CHANGE ORDER

No. 9

TITLE: C3M - Option 1 and 2 Feeder Cable Replacement
 PROJECT/CODE: SGR397 - TPSS Component Replacement
 TO: C3M
 ATTN: Salvador Benitez

SUBJECT: Option 1 & 2 Feeder Cable Replacement

Option 1D. Positive OCS Cable Replacement at E1

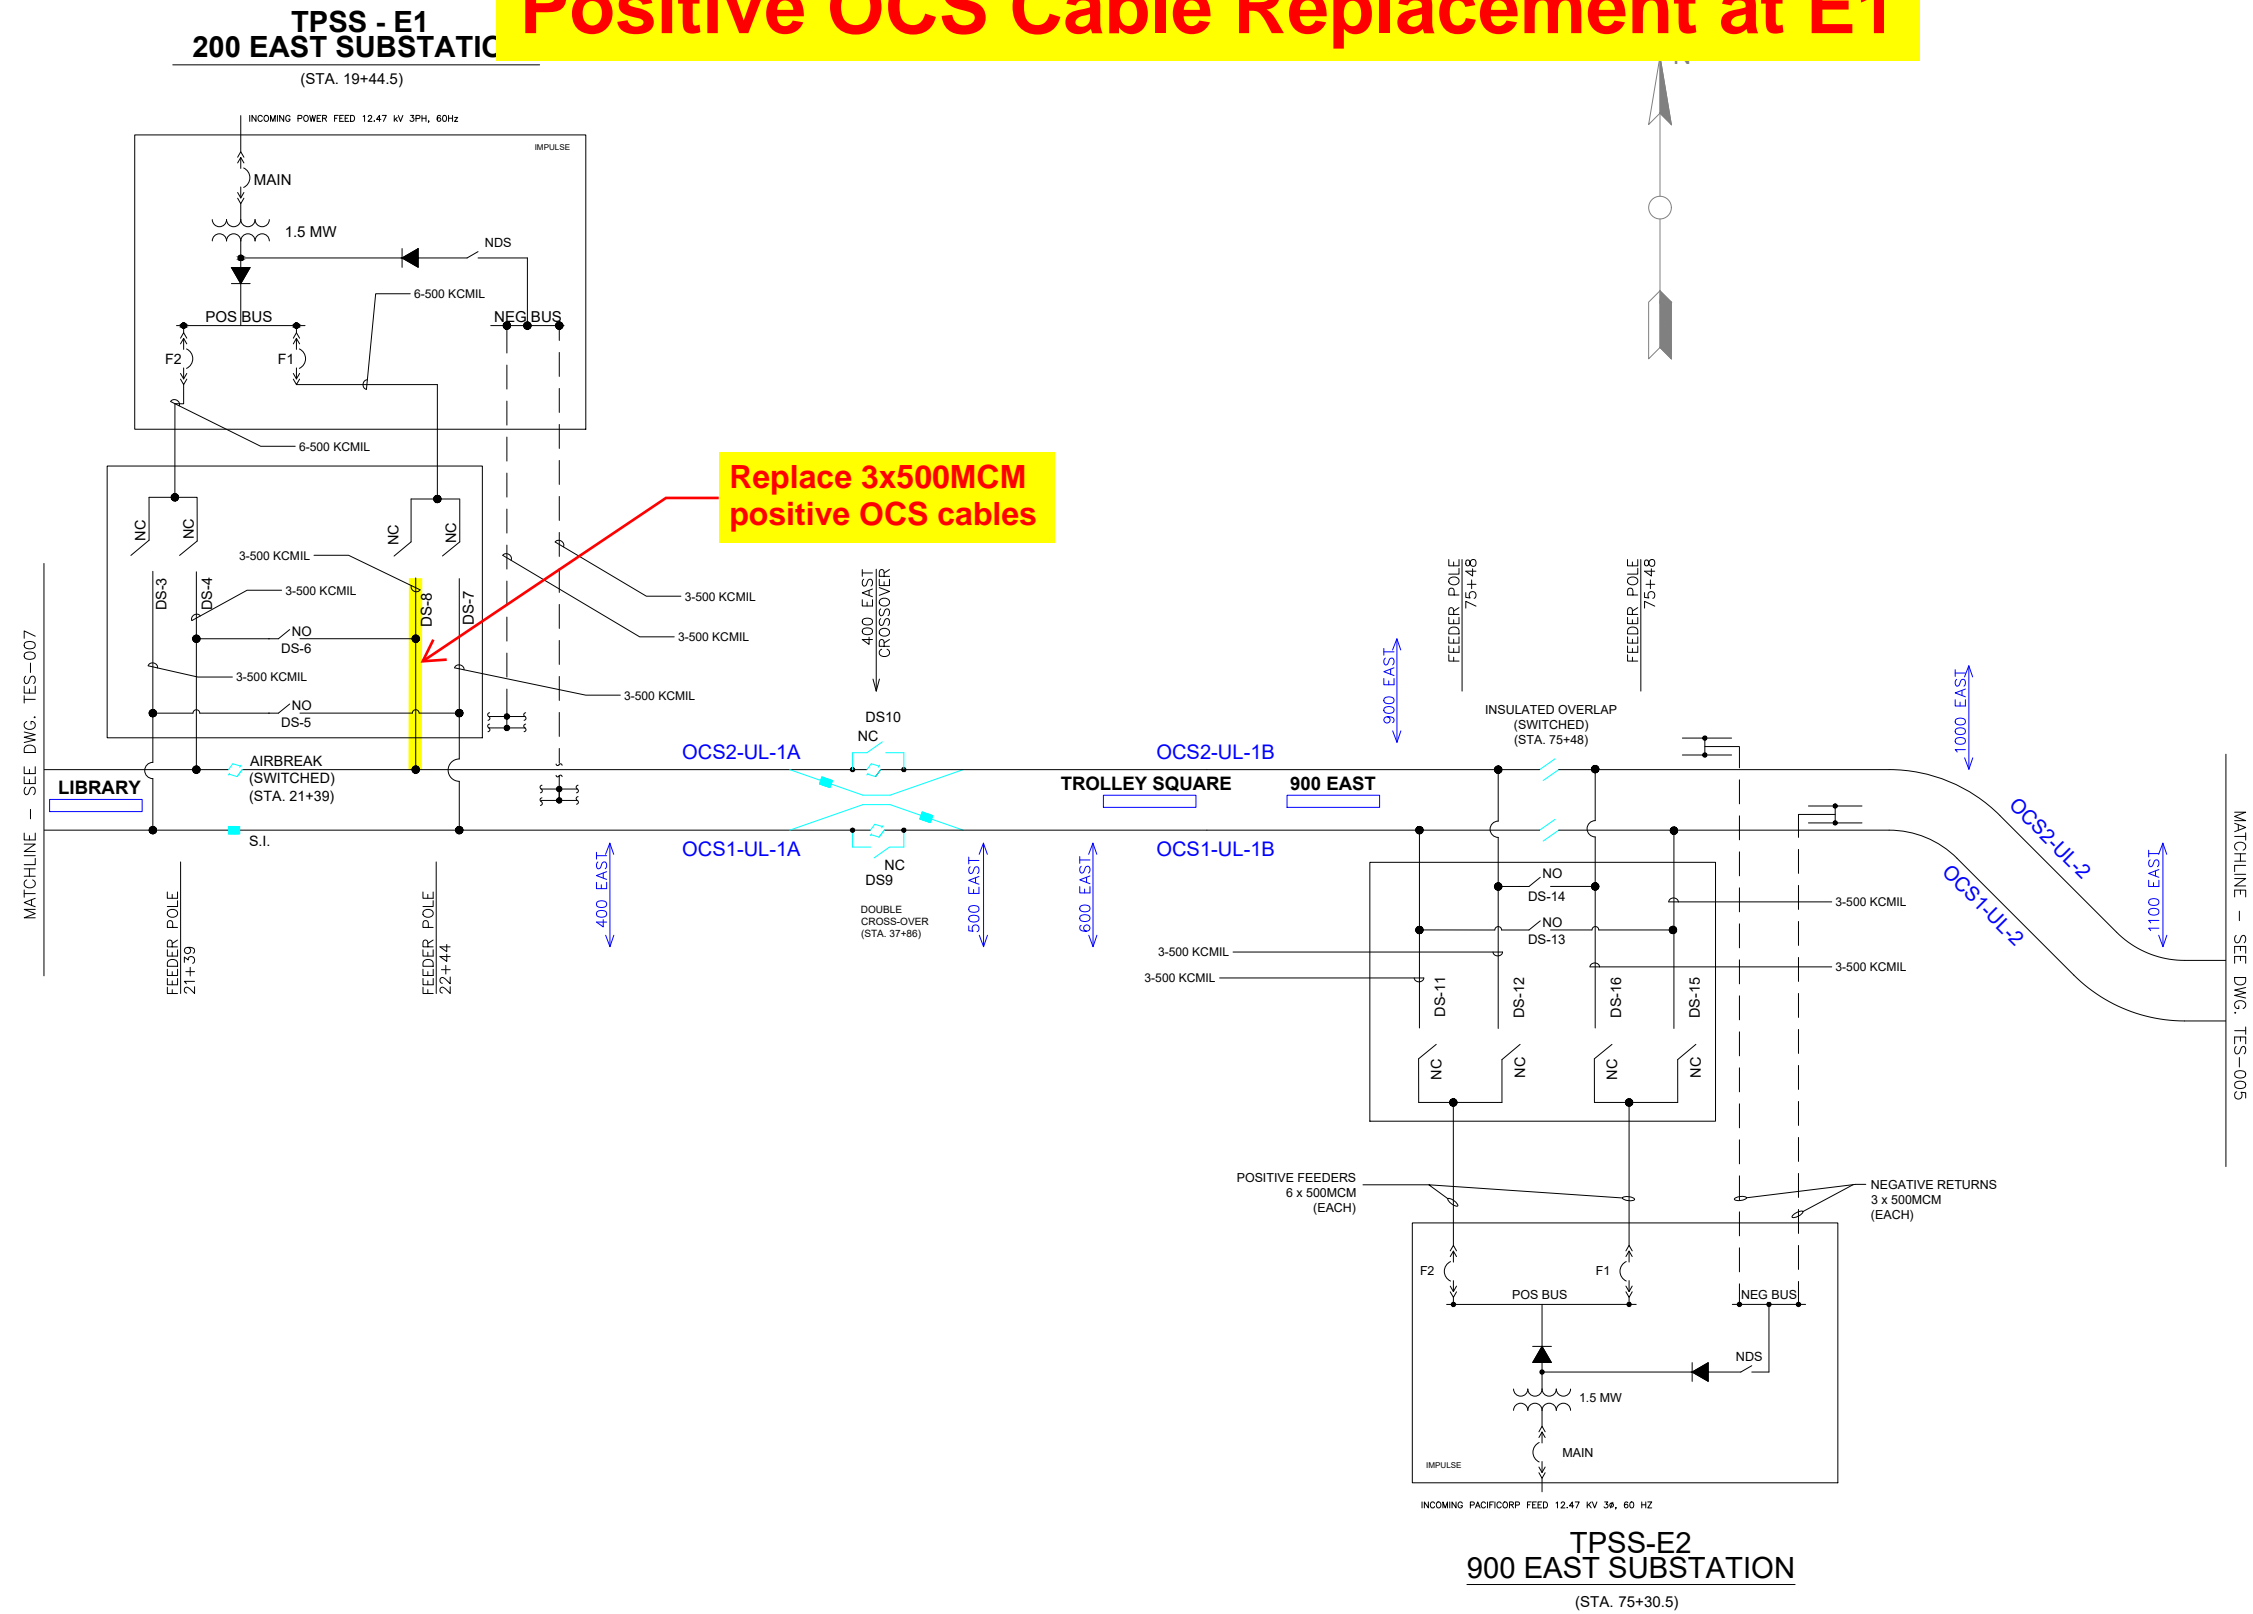
- Option 1D - E1 200 E will only replace a set of 3-500s that are feeding from DS-8 at the pad mounted disconnect to the OCS feeder pole at STA. 22+44.

TRACTION POWER SYSTEM
200 EAST SUBSTATION
UNDERGROUND RACEWAY AND CABLE PLAN
SUBSTATION TPS E1
SHEET 1 OF 2

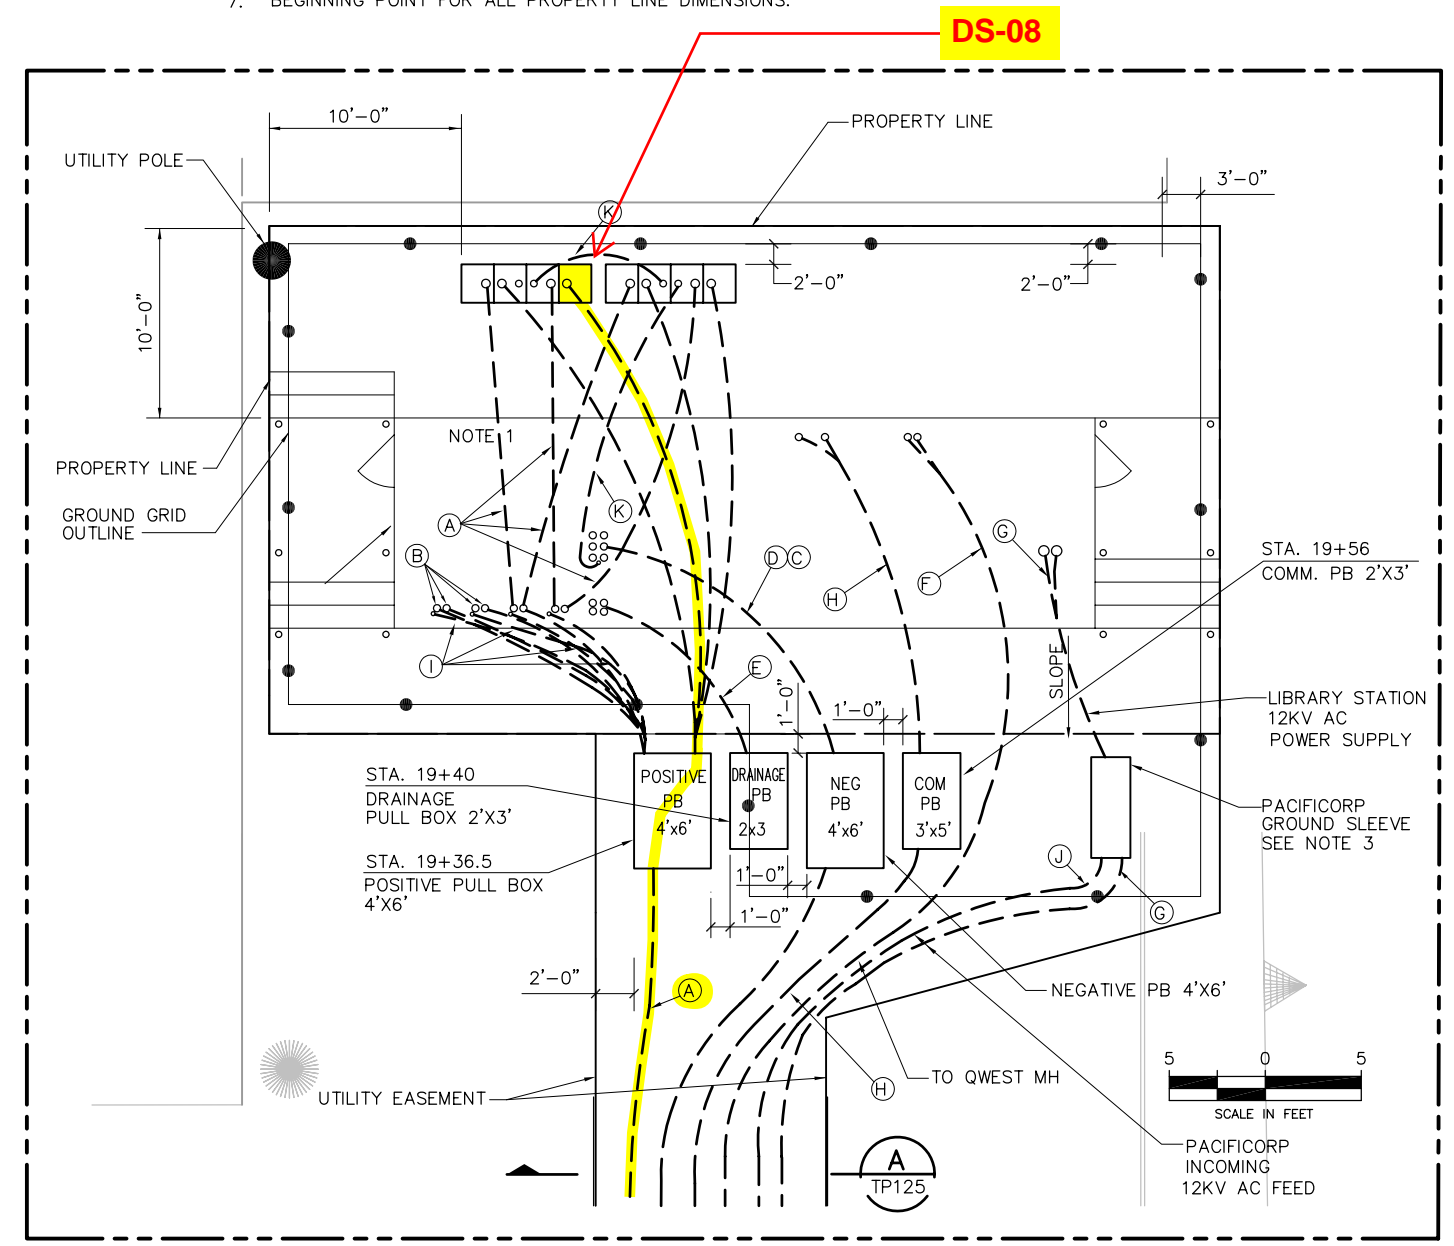
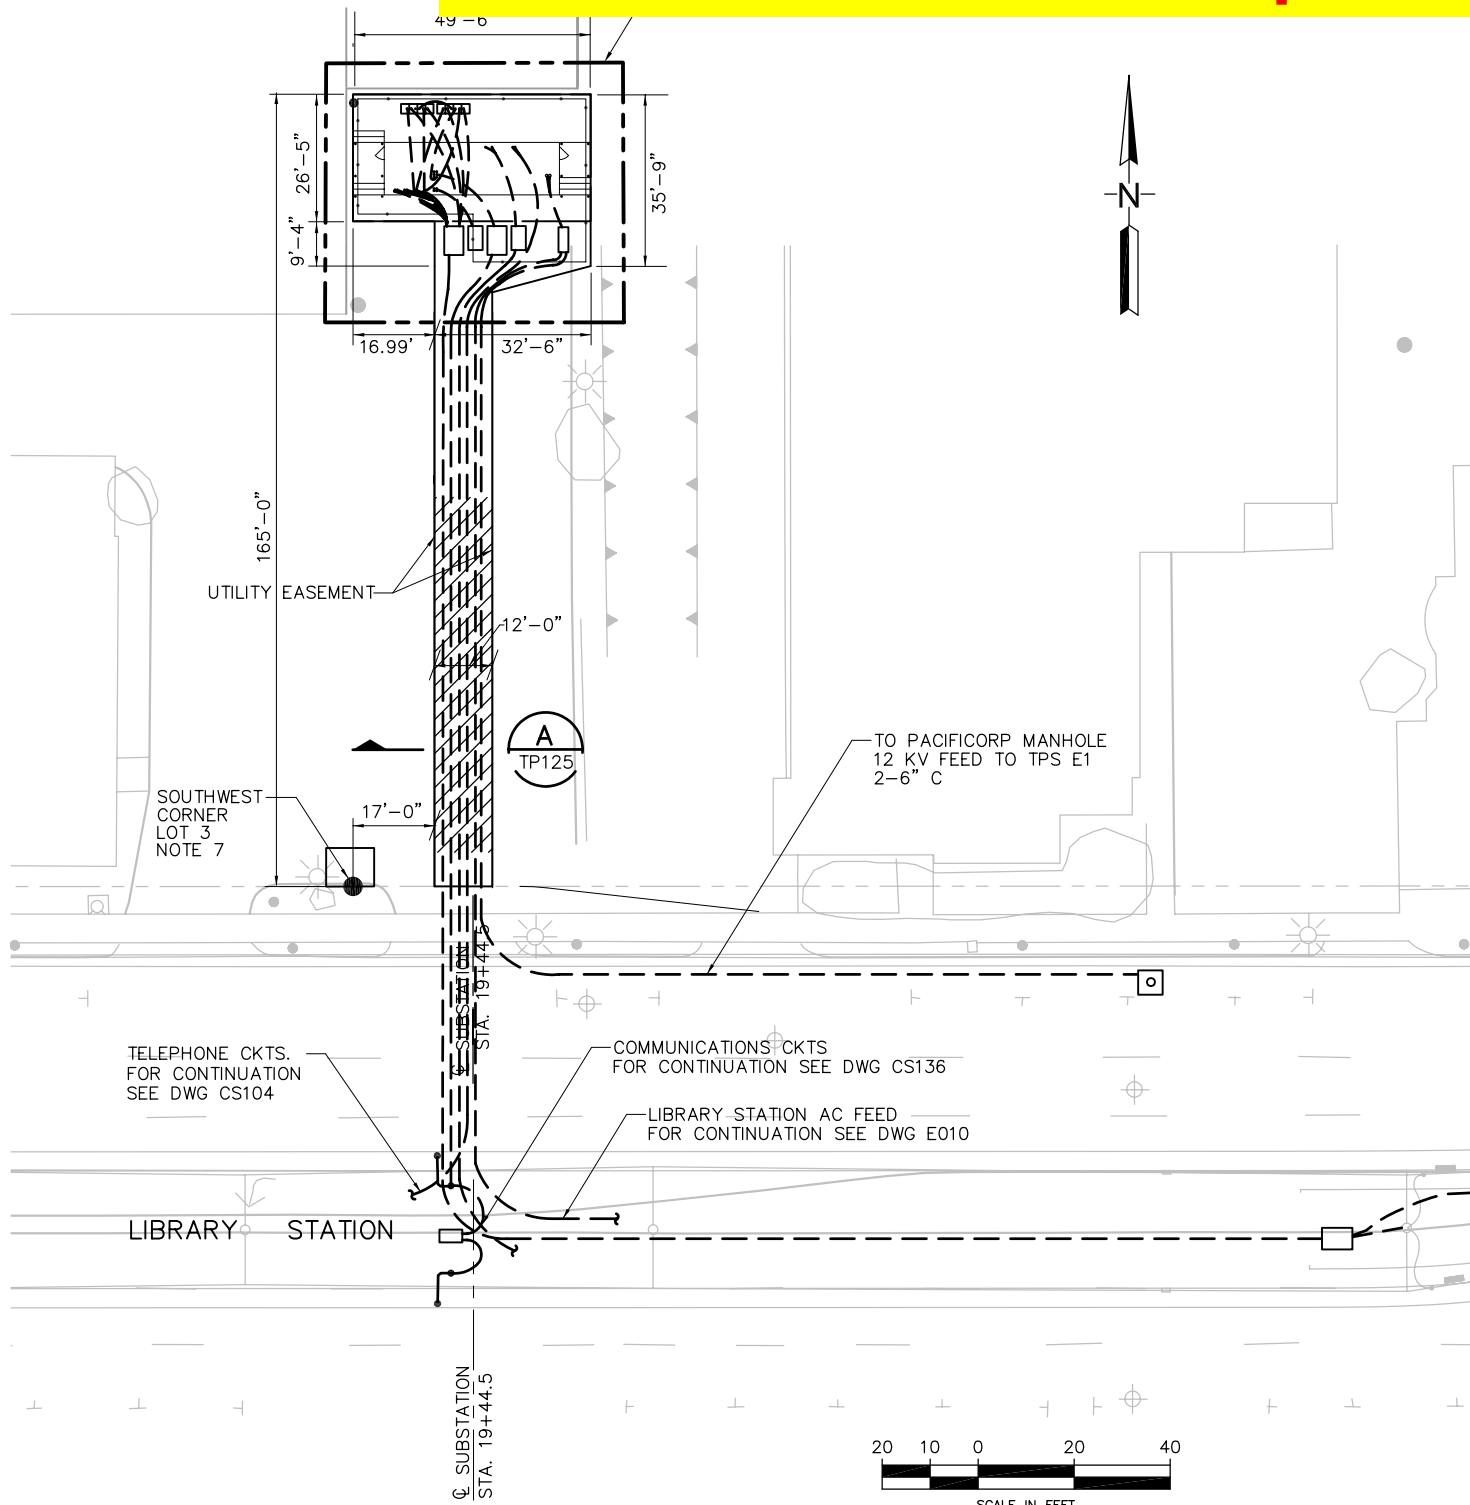
The POS feeder cables at E1 200E passed megger testing from the feeder breakers to the OCS. One cable from DS-07 to OCS tested 1GOhm but still above the 5MOhm lower limit set by UTA. Another cable from DS-08 to OCS was found to be cut at both ends (see pictures below). The cable tested good (2.2 GOhms) but is recommended for replacement to bring the system back to its original state. The two adjacent cables that share a conduit with this cable will also need to be replaced to facilitate installation. The NEG cables were not tested at this location as they are welded to the embedded rail with no impedance bonds to disconnect and test from.

Option 1E. Positive OCS Cable Replacement at E2

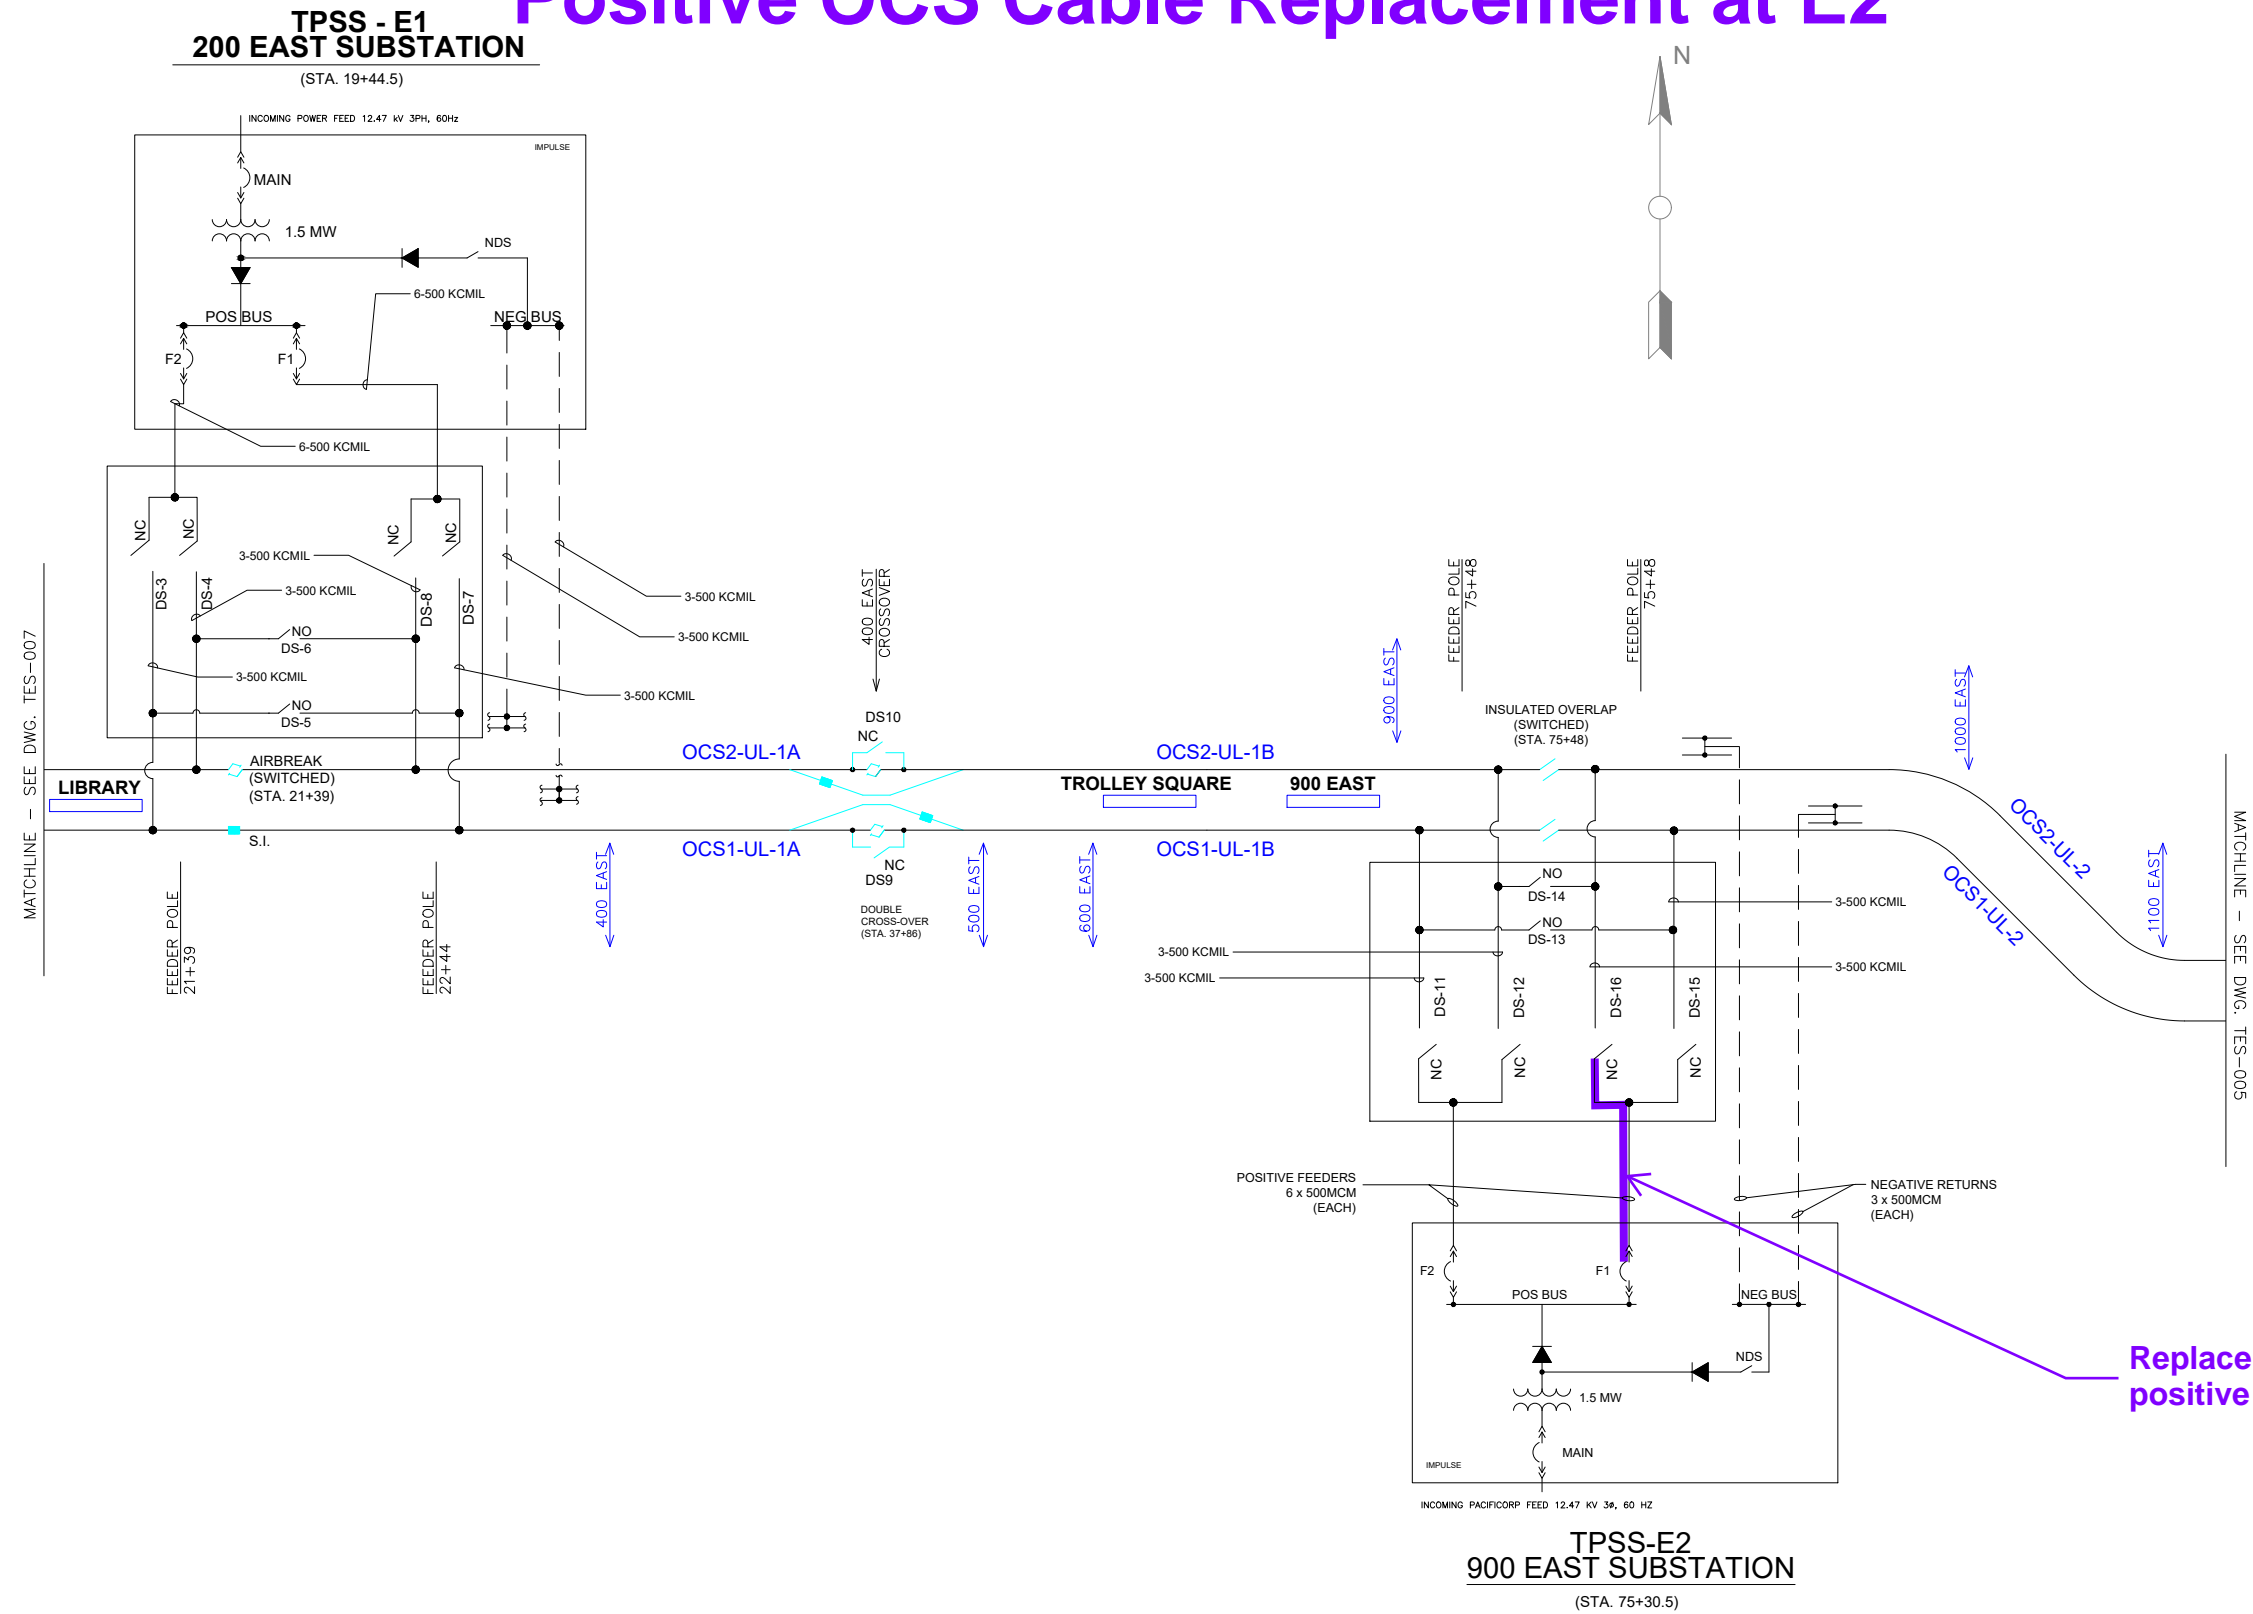
- Option 1E - E2 900 E will only replace a set of 3-500s from DC Feeder Breaker F1 to the pad mounted disconnect switch DS-16.
- Option 2D - SRS11 Sugar Highway will only replace a set of 6-500s from the negative cubicle to the termination on the northbound tracks.
